Re: Preliminary Plat for Lavitt Manor II—Two Lot Subdivision: 7525 N. Ironwood Drive

Based solely on the current Town of Paradise Valley Code and Storm Drainage Design Manual, the revised documents provided to this Commission by the Applicant for the proposed Lavitt Manor II subdivision have deficiencies requiring the Preliminary Plat be rejected:

5. PUBLIC HEARINGS 19-302 CONSIDERATION OF PRELIMINARY PLAT

PAVING GRADING DRAINAGE LAVITT MANOR II

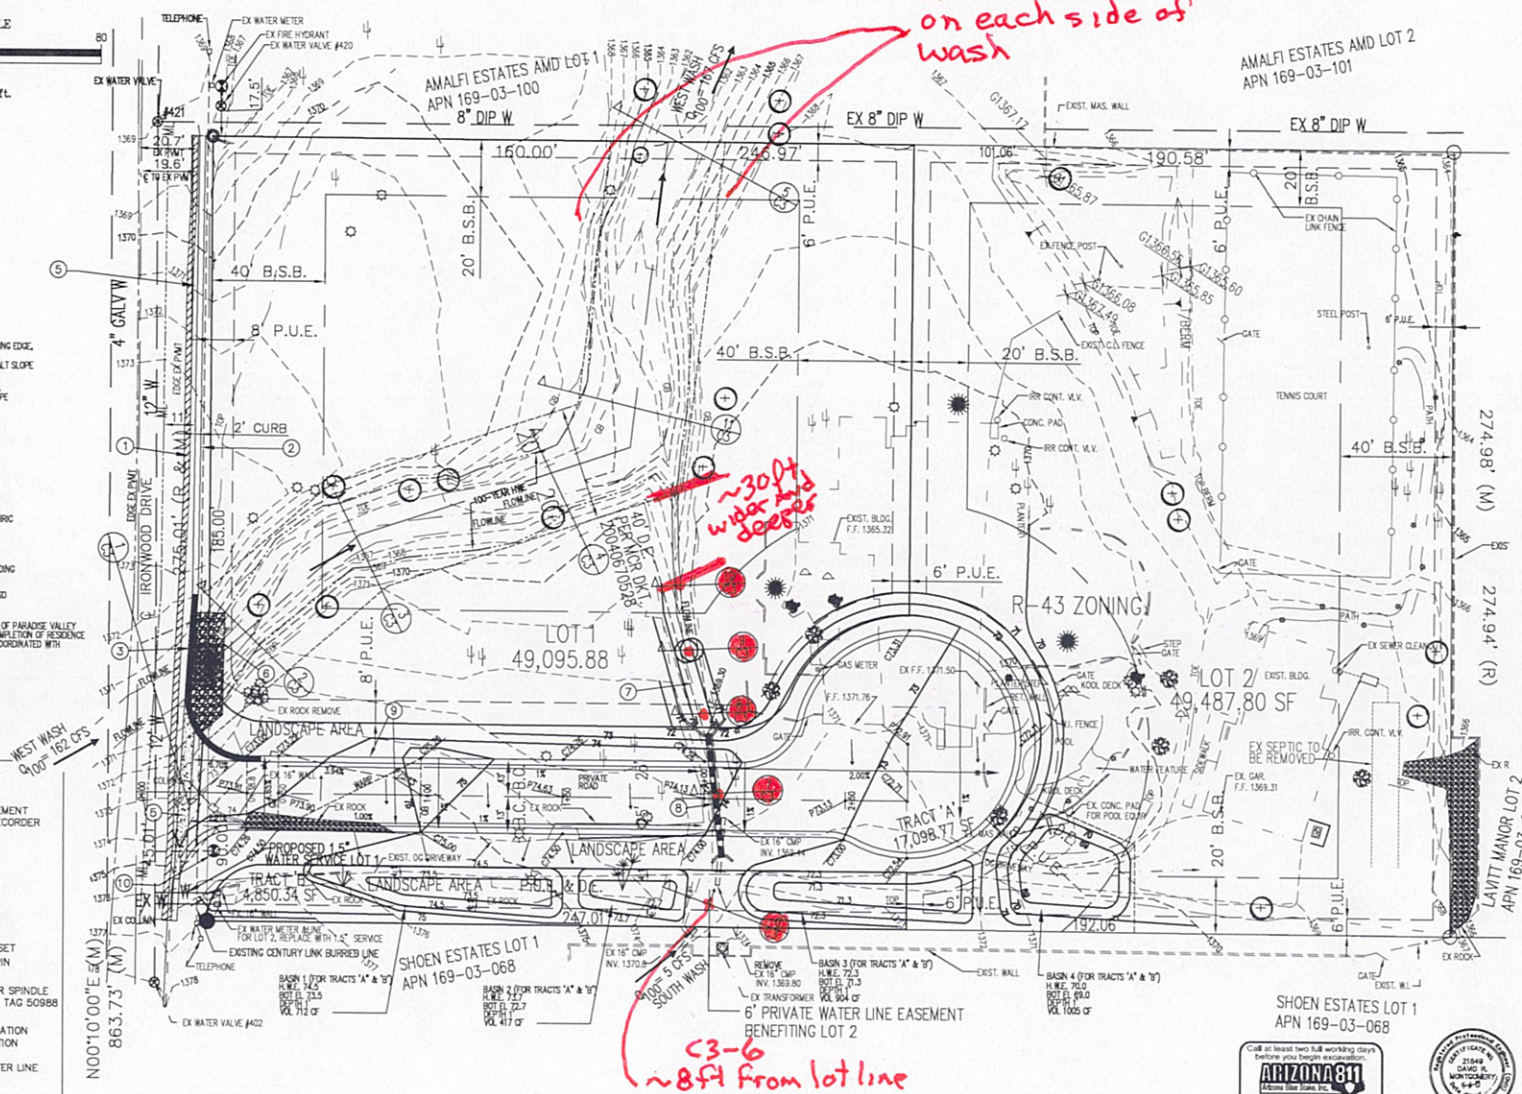
no buffer of 5'
on each side of
wash

~30ft
wider and
deeper

C3-6
~8ft from lot line

PAVING GRADING DRAINAGE LAVITT MANOR II

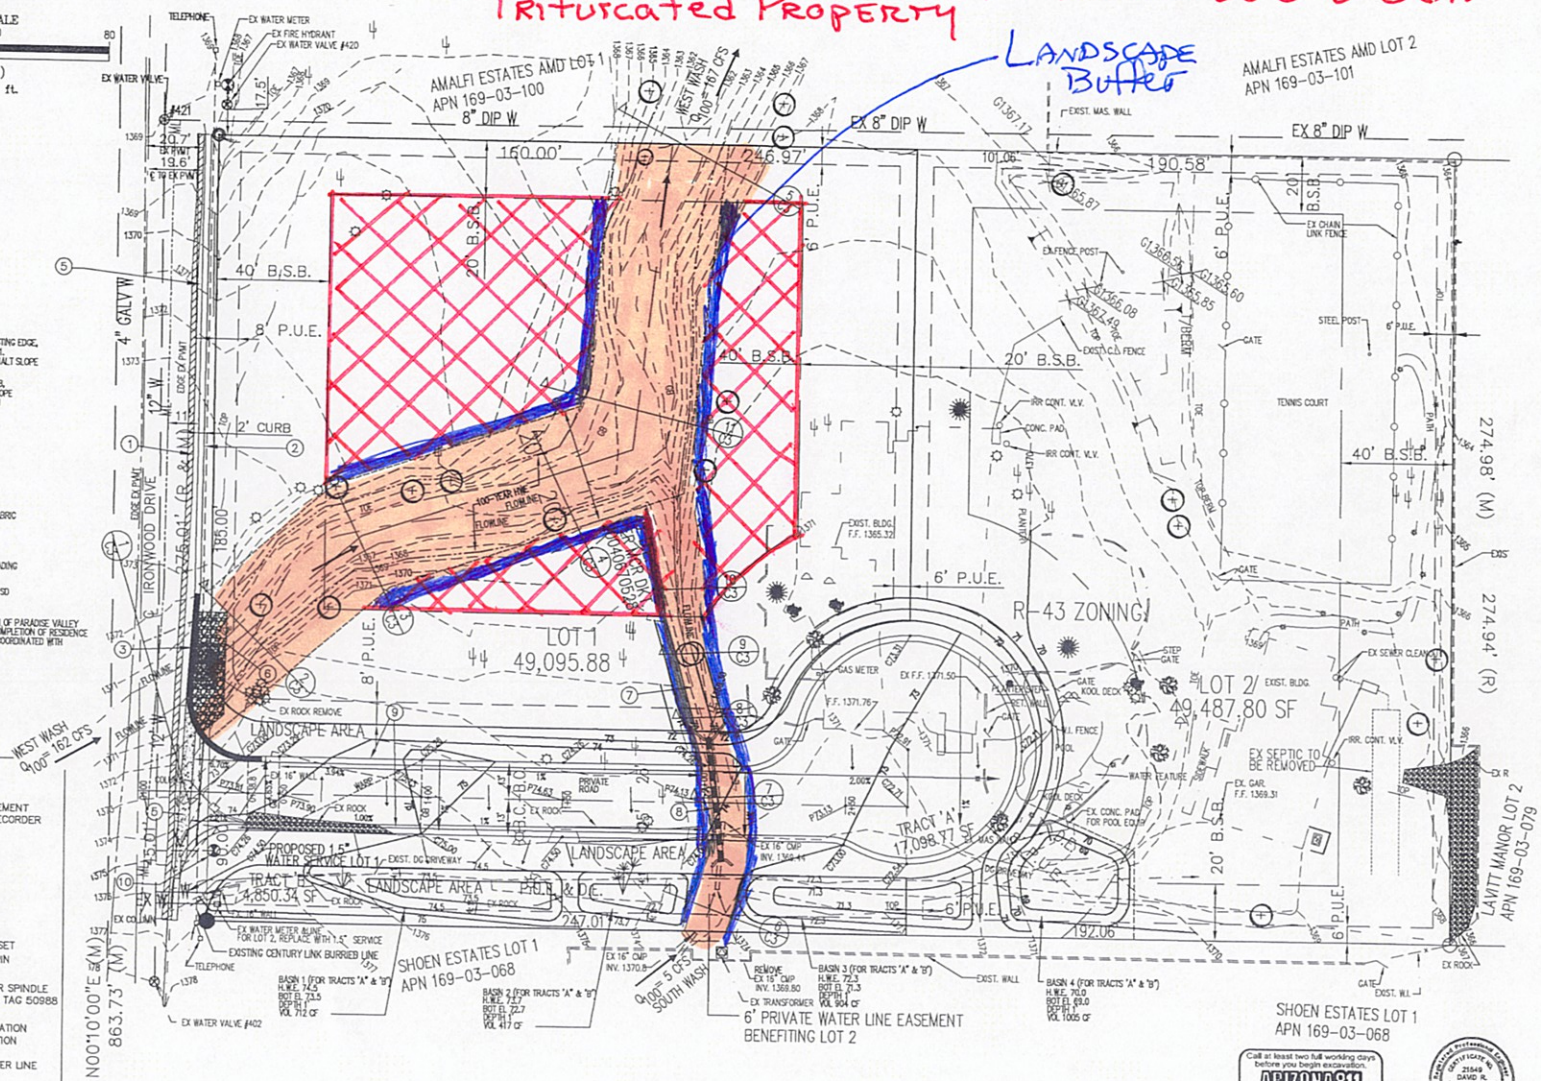
Trifurcated Property

No Satisfactory AND Desirable
Building side
PV Town Code 6-3-5(A)

LANDSCAPE
Buffer

PAVING GRADING PLAN LAVITT MANOR II

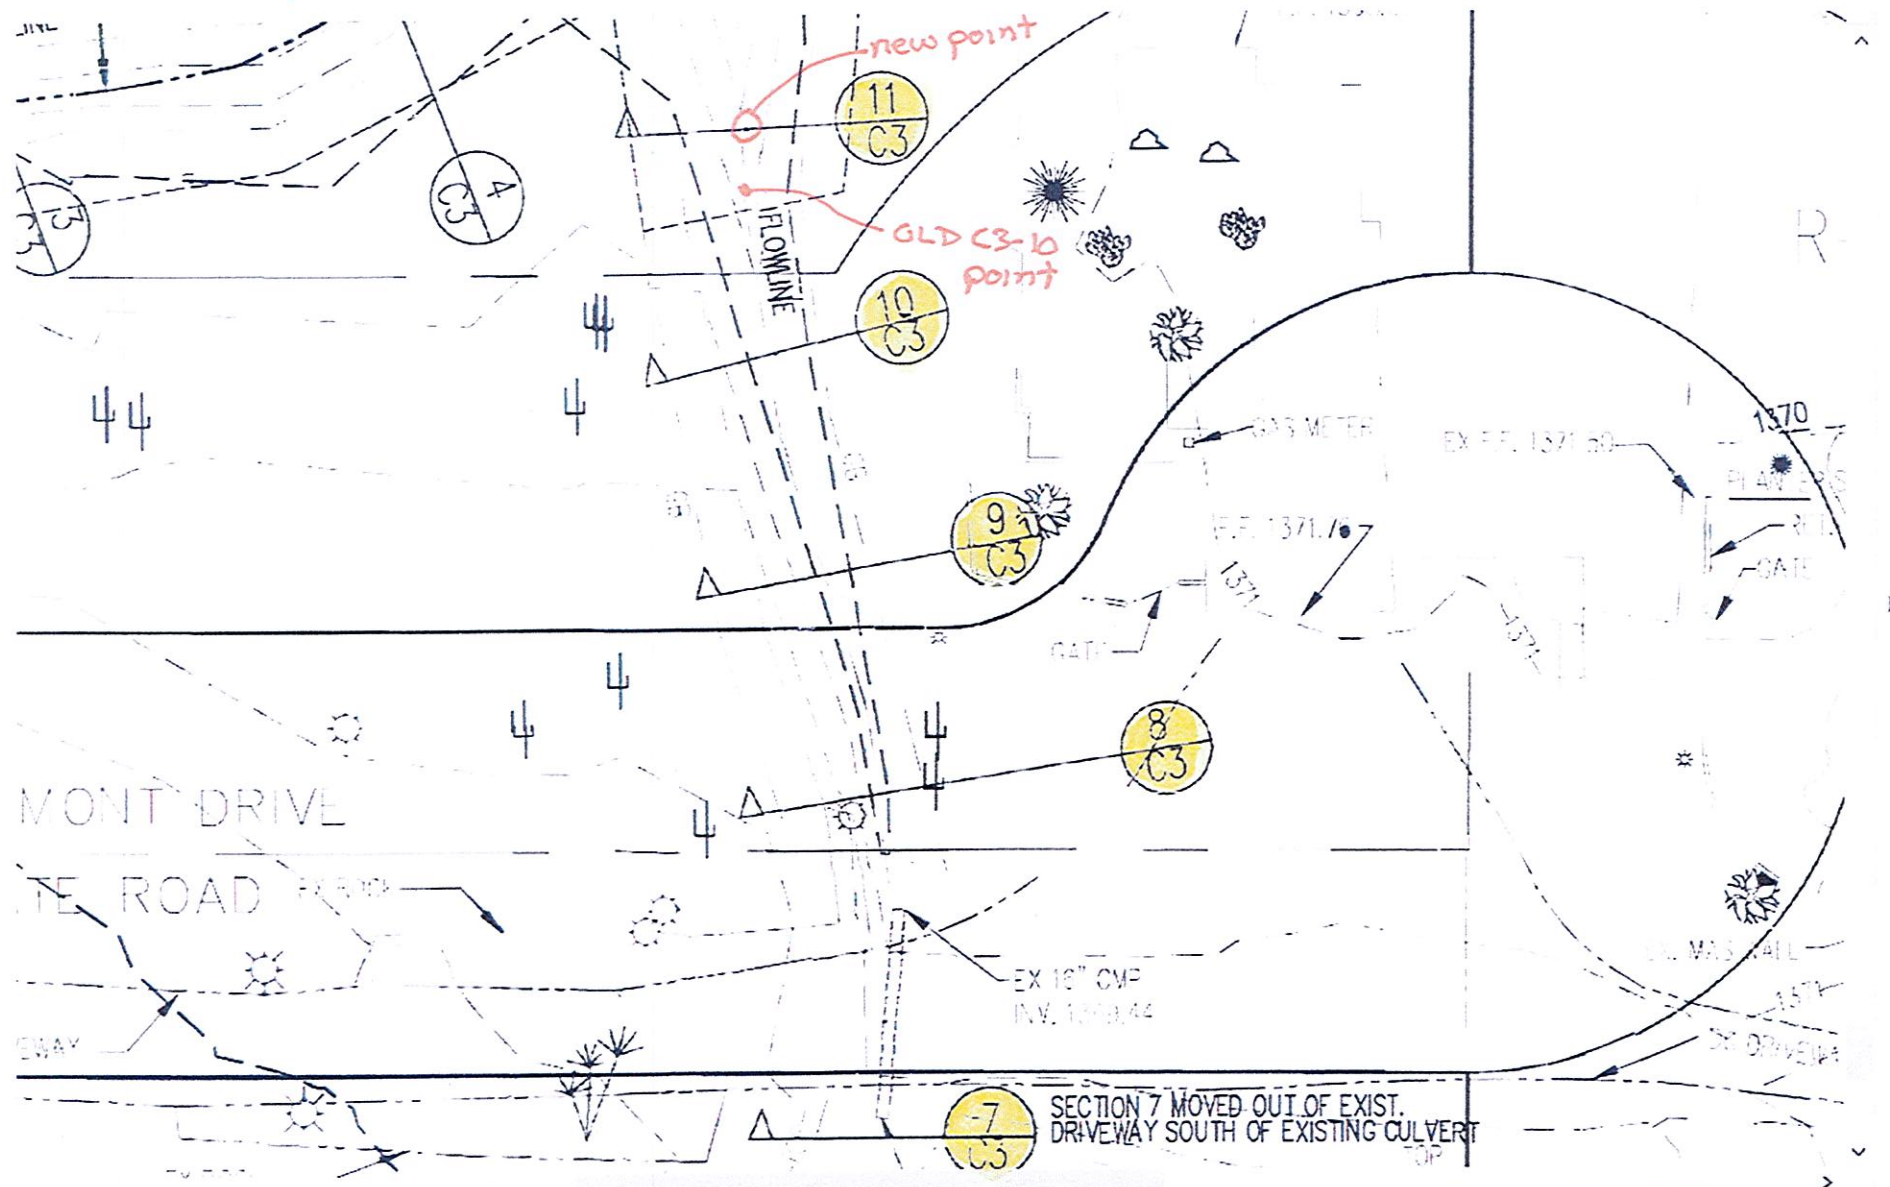
- Town of Paradise Valley is obtaining easement on Lot 1;
- Mandatory language (“shall”) to have a 5 foot landscape buffer on each side of wash;
- Current easement points approaches or encroaches Natural Wash at 3 points thus the landscape buffer is not appropriate;
- Plan should not be approved as it violates the Town Code.

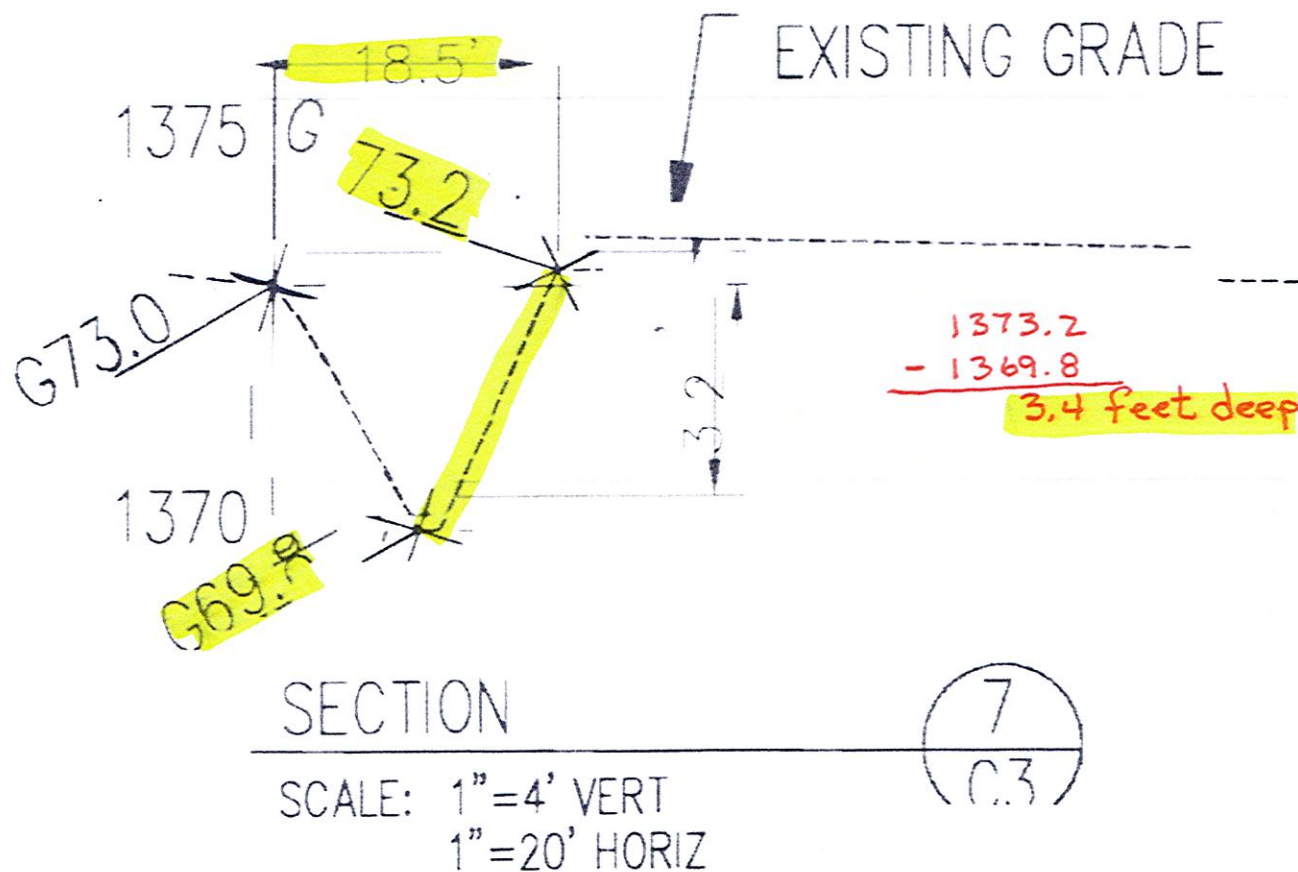
- Must consider both "historical banks" to determine depth;
- Nowhere does it say watercourse depth is taken from one bank, lowest bank, or existing grade of one bank.

- Width must be determined by taking a measurement at the "top of the bank":
 - Can only mean at the top of each bank, or one could not obtain a width measurement from one bank.
- Accordingly, to ensure the same "top of the bank" meaning throughout the provisions, "top of the bank" must mean top of each bank;
 - Depth measurements must be taken from the top of each historical bank of the wash.

- Width must be determined by taking a measurement "to the top of the bank":
 - Can only mean to the top of each bank, or one could not obtain a width measurement from one bank.
- Accordingly, to ensure the same "top of the bank" meaning throughout the provisions, "top of the bank" must mean top of each bank;
 - Depth measurements must be taken from the top of each historical bank of the wash to determine if it is a Natural Wash.

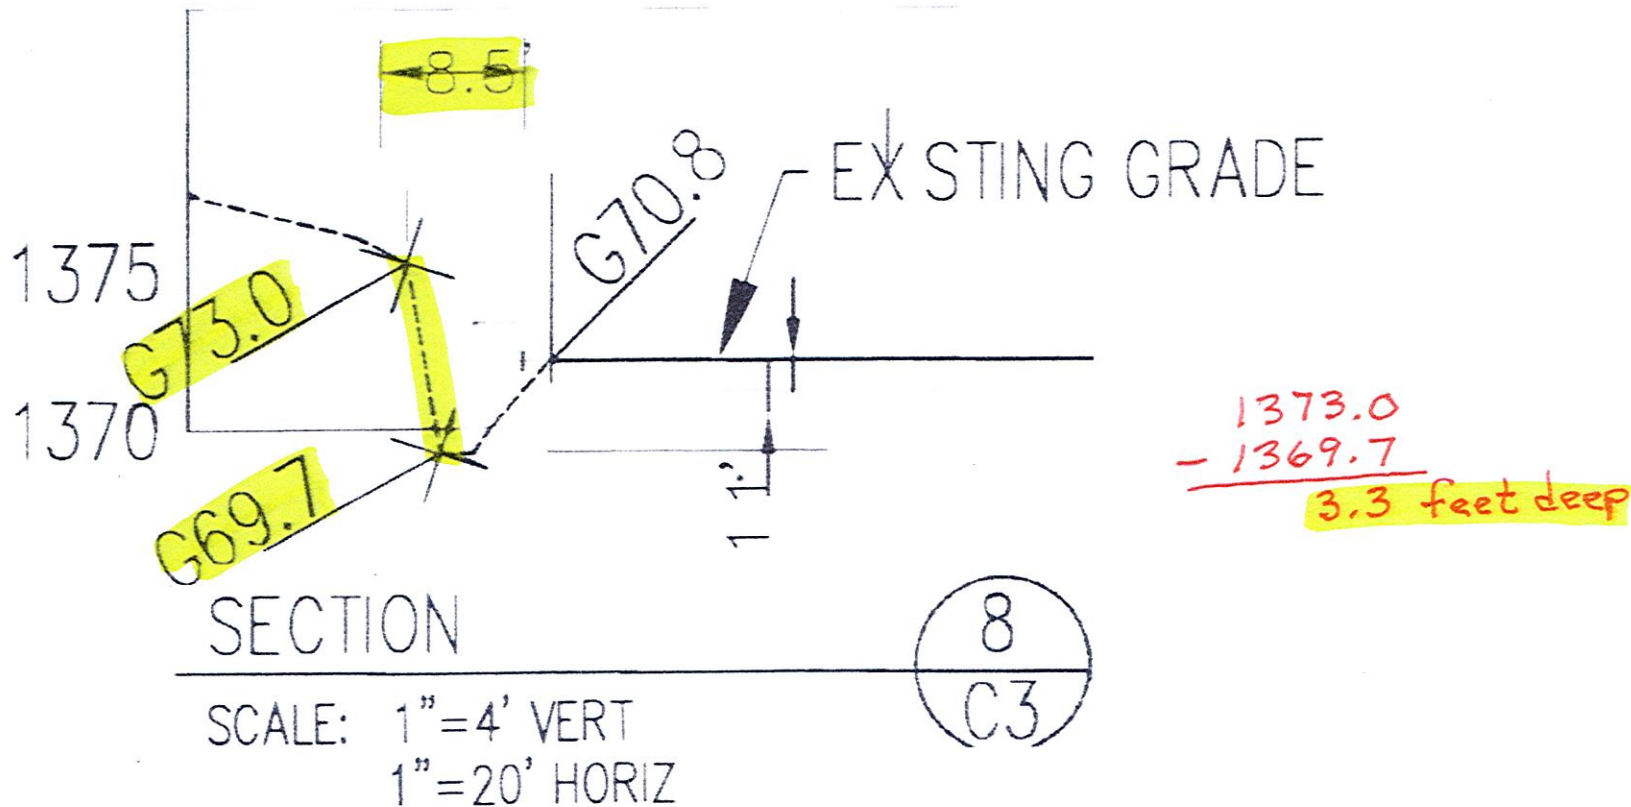
- Must consider both "historical banks" to determine depth;
- Nowhere does it say watercourse depth is taken from one bank, lowest bank, or existing grade of one bank.

- Width must be determined by taking a measurement at the "top of the bank":
 - Can only mean at the top of each bank, or one could not obtain a width measurement from one bank.
- Accordingly, to ensure the same "top of the bank" meaning throughout the provisions, "top of the bank" must mean top of each bank:
 - Depth measurements must be taken from the top of each historical bank of the wash.

- Width must be determined by taking a measurement "to the top of the bank":
 - Can only mean to the top of each bank, or one could not obtain a width measurement from one bank.
- Accordingly, to ensure the same "top of the bank" meaning throughout the provisions, "top of the bank" must mean top of each bank:
 - Depth measurements must be taken from the top of each historical bank of the wash to determine if it is a Natural Wash.

SECTION

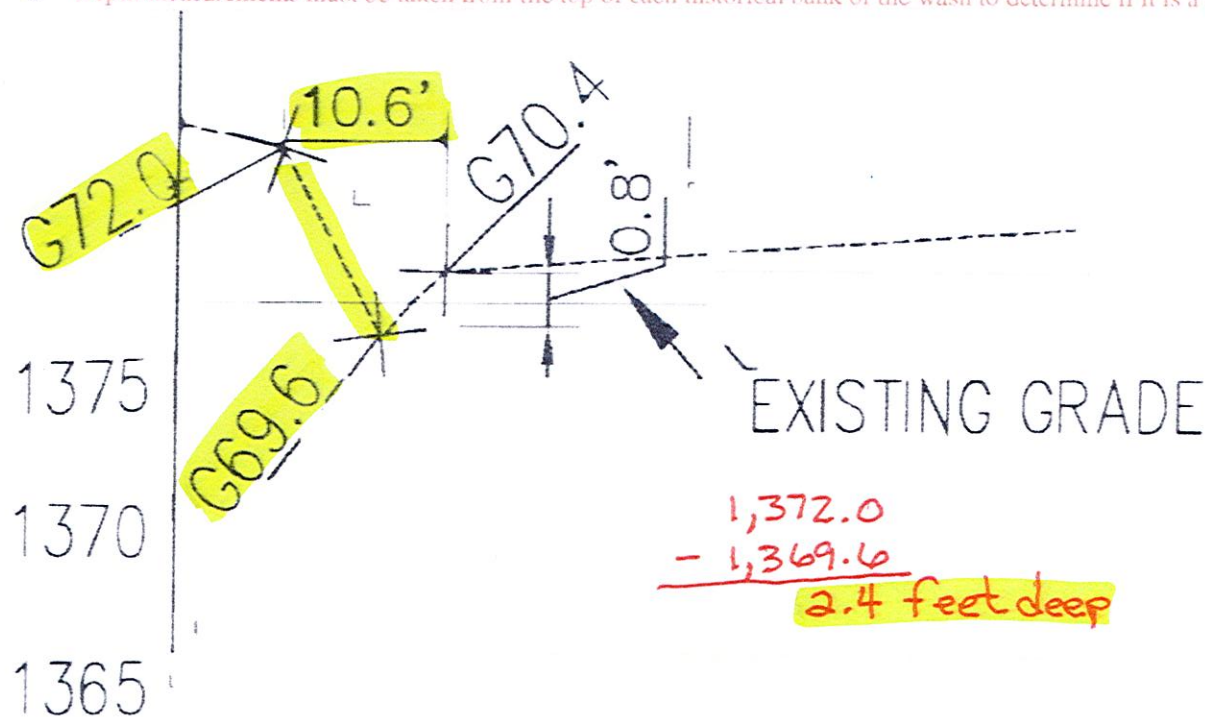
- Must consider both "historical banks" to determine depth;
- Nowhere does it say watercourse depth is taken from one bank, lowest bank, or existing grade of one bank.

SECTION

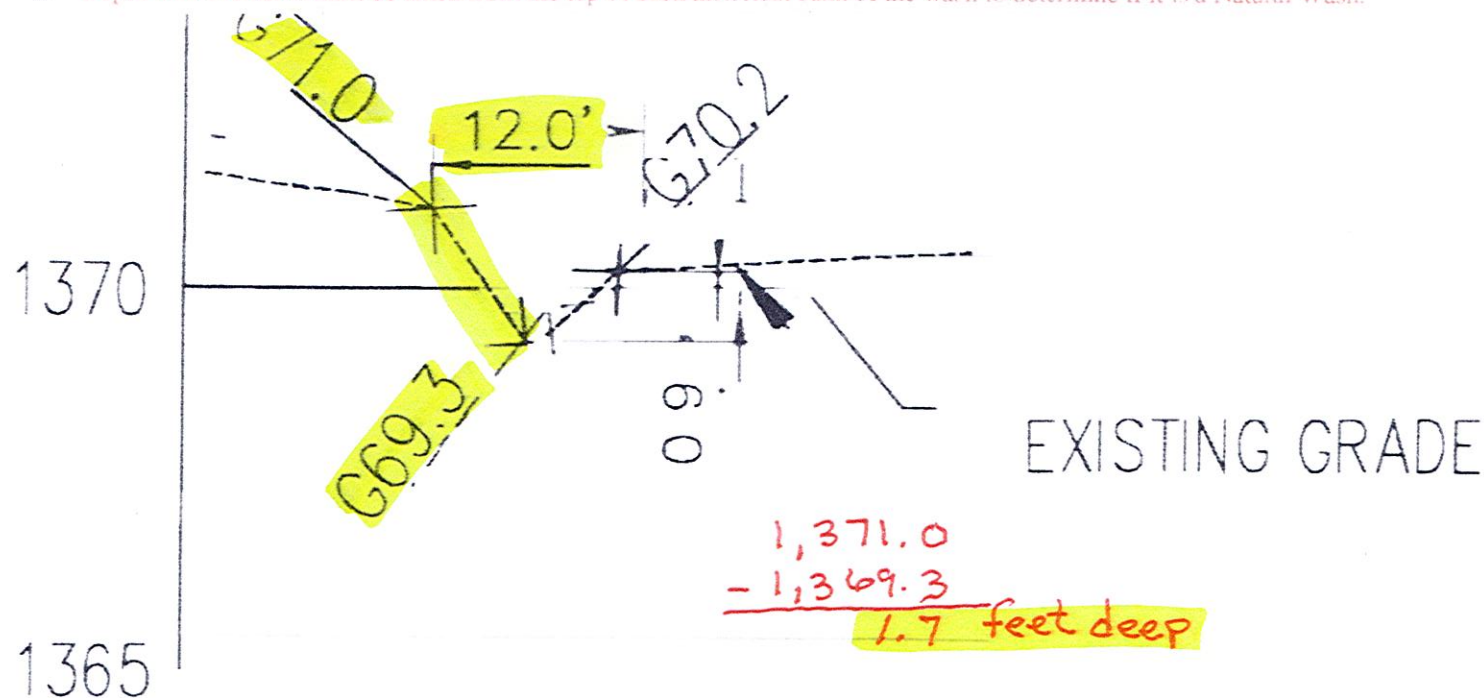
- Must consider both "historical banks" to determine depth;
- Nowhere does it say watercourse depth is taken from one bank, lowest bank, or existing grade of one bank.
